Appendix D – Ask the Consultant – Table 1

Questions for Independent Technical Consultant

Q1: Understanding the real need

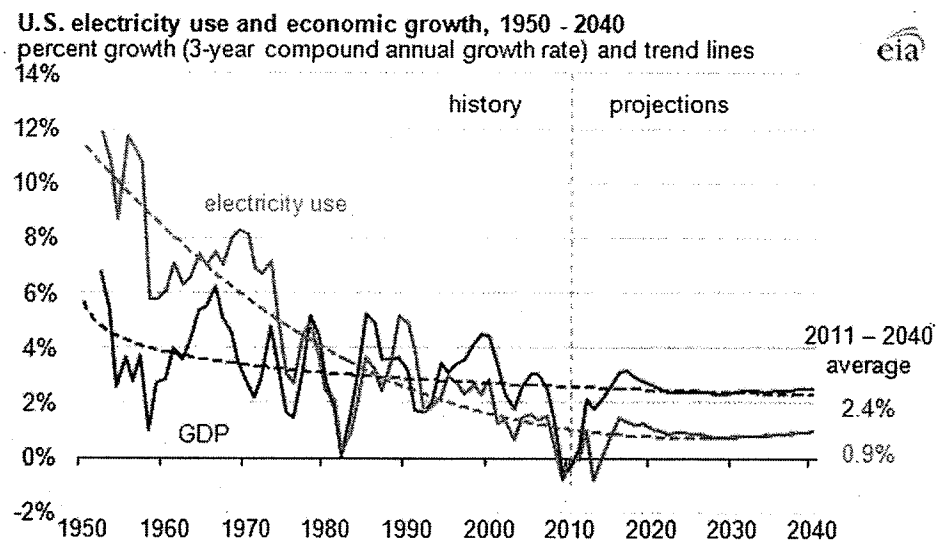
1. It's not clear to the public what this graph represents. Contrary to popular perception, this is not a graph of normal electricity use. It shows a hypothetical situation where the effects of two rare events are compounded: winter peak load demand on the Eastside which occurs only a few hours per year, and a rare equipment failure (an "N-1-1 outage" in industry parlance) on a nearby transmission line operated by a different utility. In this hypothetical situation, much of the power flowing north in the winter to Canada would be diverted from the failed line through the Eastside.

2. No historical data is provided to help us understand the theoretical trend. The data points shown for 2012, 2013 and 2014 are not actual measured values, but forecasts PSE made 4 years ago. There is evidence to suggest that the actual Eastside peak values in these years were lower.
3. The forecast rates of growth, which average 1.7% or 2.2% per year, both seem unrealistically aggressive given that Bellevue and similar cities have experienced little consumption growth over the last decade. PSE has provided no explanation of why its projection is significantly higher than the expected rates of growth for population or the economy of the Eastside. PSE's projections are much higher than growth rates predicted for comparable cities such as Seattle and Portland, and for the Northwest region as a whole. Why is the Eastside so different?

FIGURE 5: LOAD HISTORY AND 2012 IRP FORECAST (WITH NO NEW PROGRAMMATIC CONSERVATION)

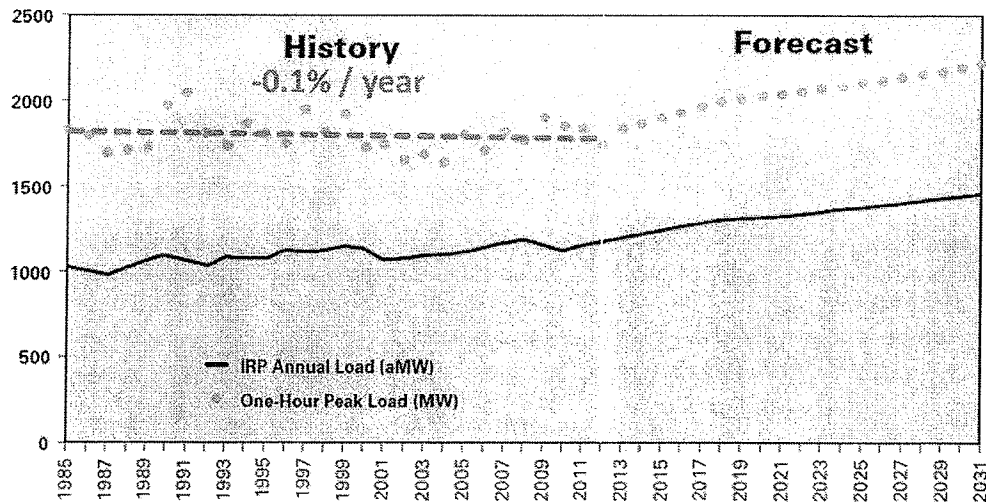
We note that peak load (the same as “demand” in PSE’s graph) has been gradually declining in Seattle for the past 27 years, despite significant economic and population growth during that period. Also, Seattle’s forecast rate of growth is less than half of PSE’s. Similar trends are occurring in Portland.

We ask the consultant to produce an analogous graph for the Eastside that shows the following data, with values independently determined by the consultant using unfiltered, raw data from PSE or other sources:

1. Time period from 2000 to 2030 (15 years of historical data, and a forecast for the next 15 years).
2. Values for “One-Hour Peak Load (MW)” with grid outage (N-1-1 state in Q3 below).
3. Values for “One-Hour Peak Load (MW)” with no grid outage (N-0 state).
4. Values for “Annual Average Load (aMW)” with grid outage (N-1-1 state in Q3 below).
5. Values for “Annual Average Load (aMW)” with no grid outage (N-0 state).
6. A line showing existing “System Capacity” (which PSE shows as approximately 710 MW on its Forecast) including any allowable increase for temporary loads. We would like the consultant to independently verify PSE’s value.
7. A line showing the future “System Capacity” of Energize Eastside, including any allowable increase for temporary loads, which we would like the consultant to independently verify.
8. A line showing the Total Transfer Capacity of Energize Eastside.

The Eastside's electric demand

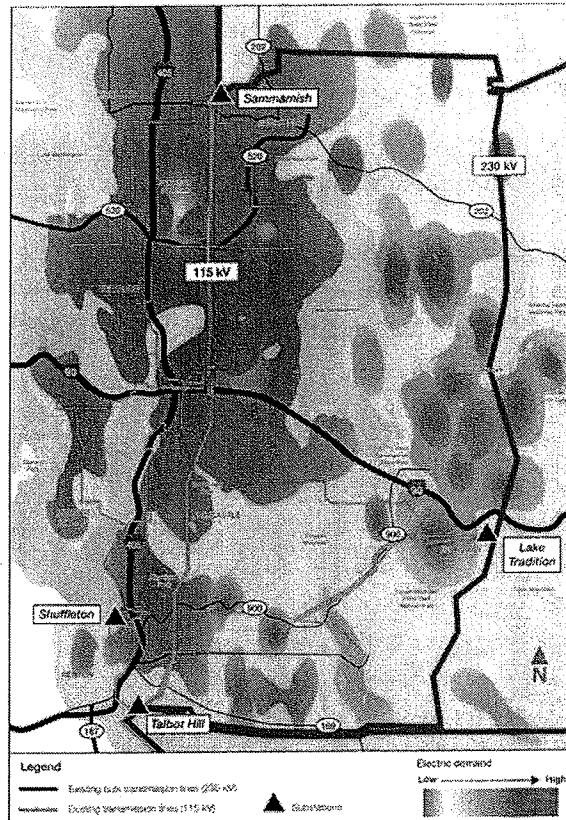
Unfortunately, the methodology used to create this map is unsound. We have been told by PSE that it combines peak use data from both summer and winter peaks which occurred over 5 years ago. The inclusion of summer peak data is not relevant to the winter peak problem Energize Eastside seeks to address and makes the problem look much worse.

Furthermore, the data was “scaled and smeared” to “protect consumers’ privacy.” The result of these manipulations suggests that Mercer Island is using electricity at the same intensity as downtown Bellevue, which is hard to believe.

We ask the consultant to create a more accurate map showing winter peak loads for the same area shown in PSE’s map. The updated map should show data from a representative winter peak which occurred no more than 2 years ago. To provide adequate detail, data should come from measurements of peak loads at the level of individual distribution substations. An accurate map is important, because localized peaks might be addressed by localized solutions. Some may represent prime opportunities for conservation.

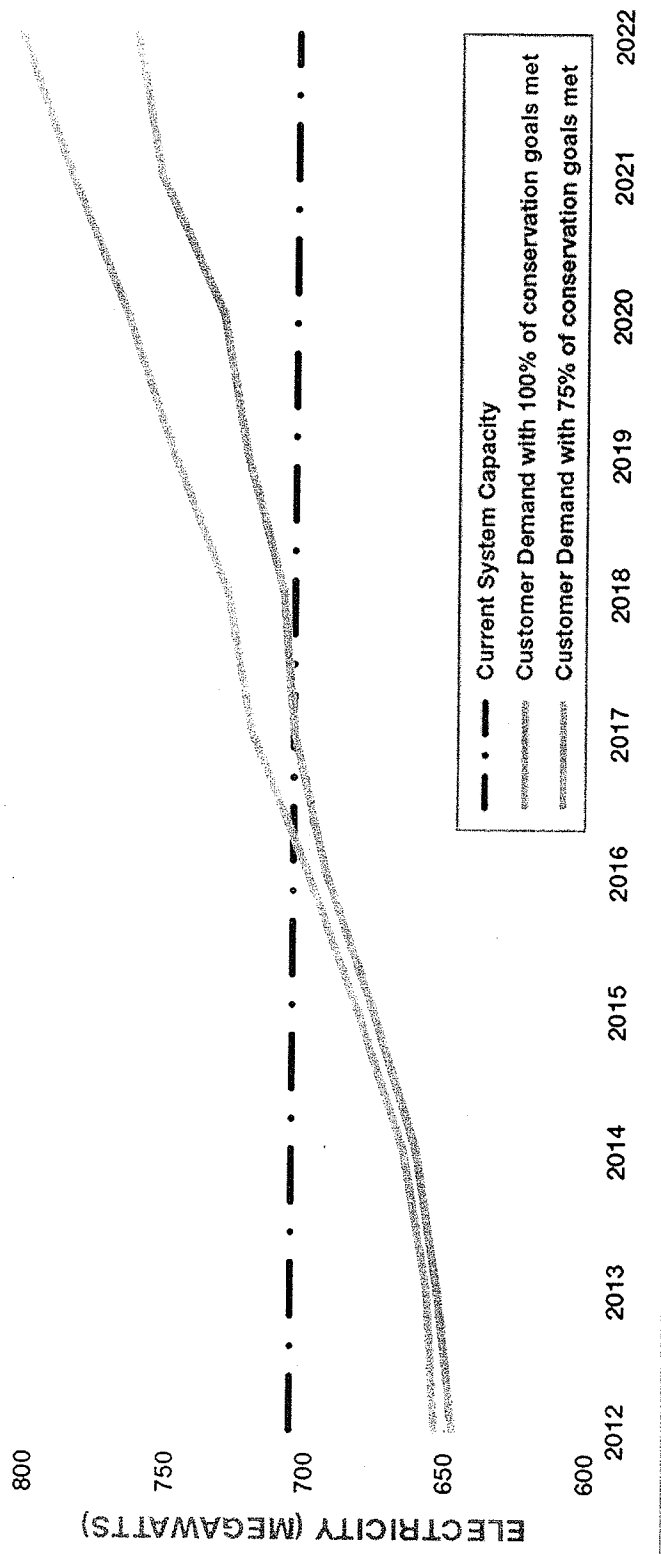
We have highlighted the 845 MW predicted load for the Eastside.

These facts suggest that Eastside infrastructure can cope with at least 130 MW more than the ~710 MW "System Capacity" noted on PSE's Eastside Customer Demand Graph:

Can USE explain this apparent discrepancy to us? Has PSE already raised System Capacity with the improvements listed in the "Other Adjustments Modeled" in this scenario? What factors determine the System Capacity line on PSE's graph, and does this reflect current capacity, or capacity that existed in 2012 when the forecast was created?
